SERVICE BULLETIN

Ref: SRV-020-006

Product: 200 Series AirFlex, SDX and Grain Belt Headers

Re: Reel Speed Issues Fendt/Ideal Combines

Figure 1

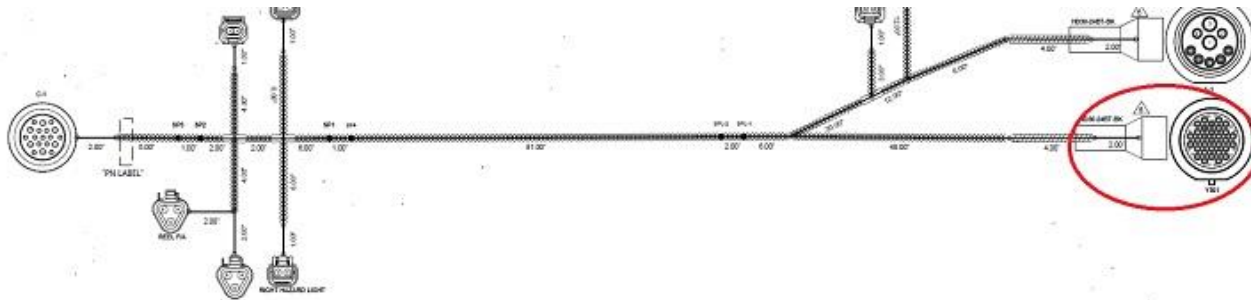
On the multi-coupler harness that connects the combine to the relay control panel, Figure 1 and 2, there is a ground wire on this harness in the wrong location. To repair the harness, it will require a Deutsch connector pin removal tool.

Figure 3

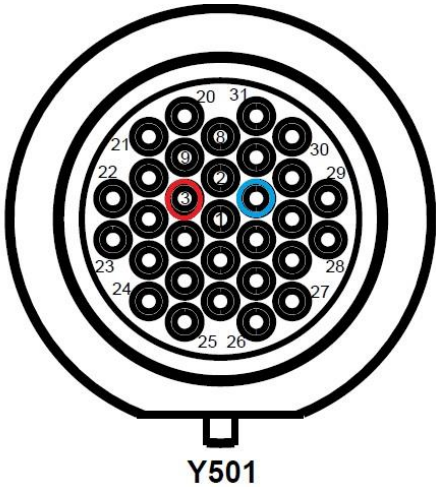
- On the 31-pin connector that attaches to the combine wire harness, Y501, remove pin #7 from the connector and tape it back to the harness. Figure 3.
- Remove pin #3 from the connector and move it to the #7 hole in the connector. Figure 4.
- This will work for both brand of combines by having the right ground signal go to the combine.
